# UNITED STATES PATENT AND TRADEMARK OFFICE

10/531,104

<b>Office Action Summary</b>	<b>Application No.</b> 10/531,104	<b>Applicant(s)</b> LAIHO, KIMMO	
	<b>Examiner</b> Khanh Dang	<b>Art Unit</b> 2111

## **DETAILED ACTION**

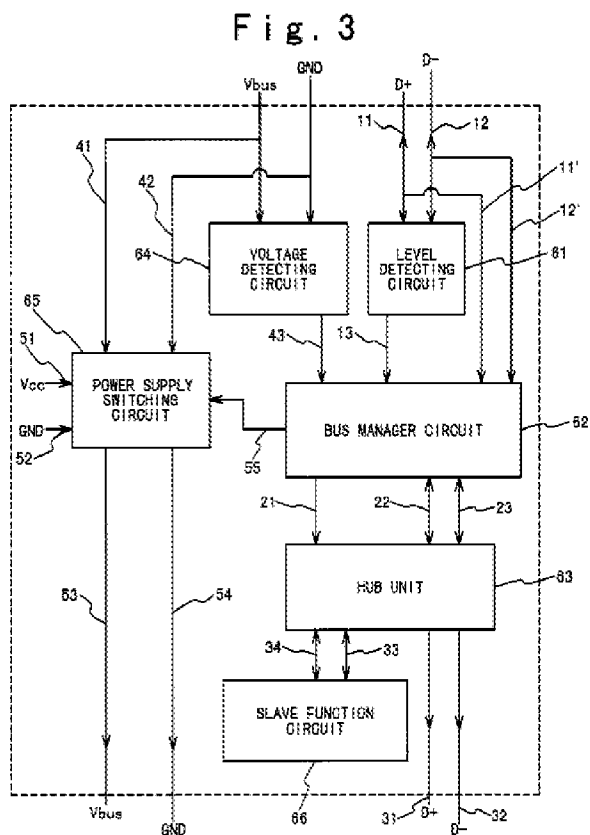
With regard to claim 1, Oguma discloses a device operable as a host device (as shown generally in Fig. 3, which is reproduced below for ease of convenience and reference, the portable device comprises a bus manager circuit can be operable as a host device)

comprising: a port connected to a bus (as shown in Fig. 3, USB port of the portable device provides connection to the USB bus comprising Vbus, GND), means for detecting the presence of another host connected to the bus and for relinquishing host status in response thereto (the voltage detecting circuit 64 is readable as the so-called "means for detecting." When the detecting circuit 64 detects presence of another host 1 connected to the USB bus, the host status of the portable device is relinquished. See at least column 2, lines 39-57, column 4, line 65 to column 6, line 17).

Figure 3

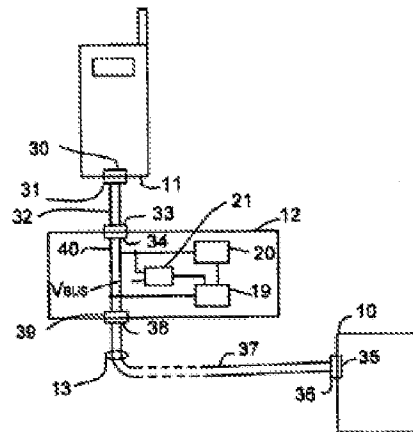
In response to Applicants' argument, at the outset, Applicants' Fig. 3 is reproduced below for comparison.

As shown in Applicants' Fig. 3, element 12 is the so-called "device operable as a host device," element 33 is the "first port," element 38 is the "second port," element 19 is the "host module," element 20 is a "comparator," and element 10 is the so-called "host externally connected to the bus."

Fig. 3

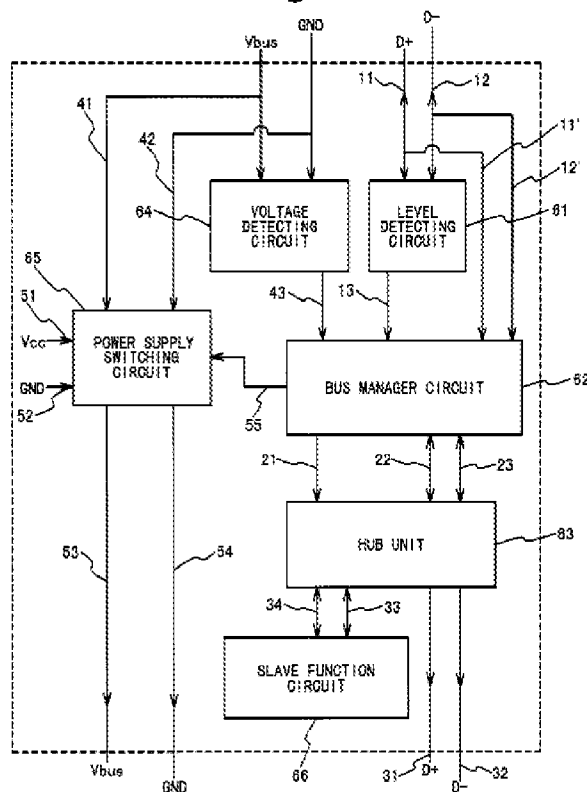
Thus, contrary to Applicants' argument, Fig. 3 of Oguma, which is reproduced below for ease of reference and comparison, shows the so-called "device operable as a host." Further as shown in Fig. 3, the device includes a USB bus comprising Vbus, GND, D+, and D-. The device further comprises a first upstream port connected directly to the USB bus; and a second downstream port connected directly to the same USB bus running from the first upstream USB port to the second downstream USB port. The device as shown in Fig. 3 of Oguma also shows the so-called "host module" or bus manager circuit 62 connected directly to the same USB bus; and the "comparator" or voltage circuit 64 detecting coupled to the same USB bus to detect the presence of a

host externally connected to the USB bus. A voltage detecting circuit basically comprises a voltage comparator for comprising a supply voltage with a reference voltage (VREF) to detect a change in voltage or a difference between supply voltage and reference voltage. Further, as noted above, a USB bus comprises Vbus, GND, D+, and D-. It is also important to note that Applicants' Fig. 3 shows a Vbus line, and other lines are grouped together as line 40.
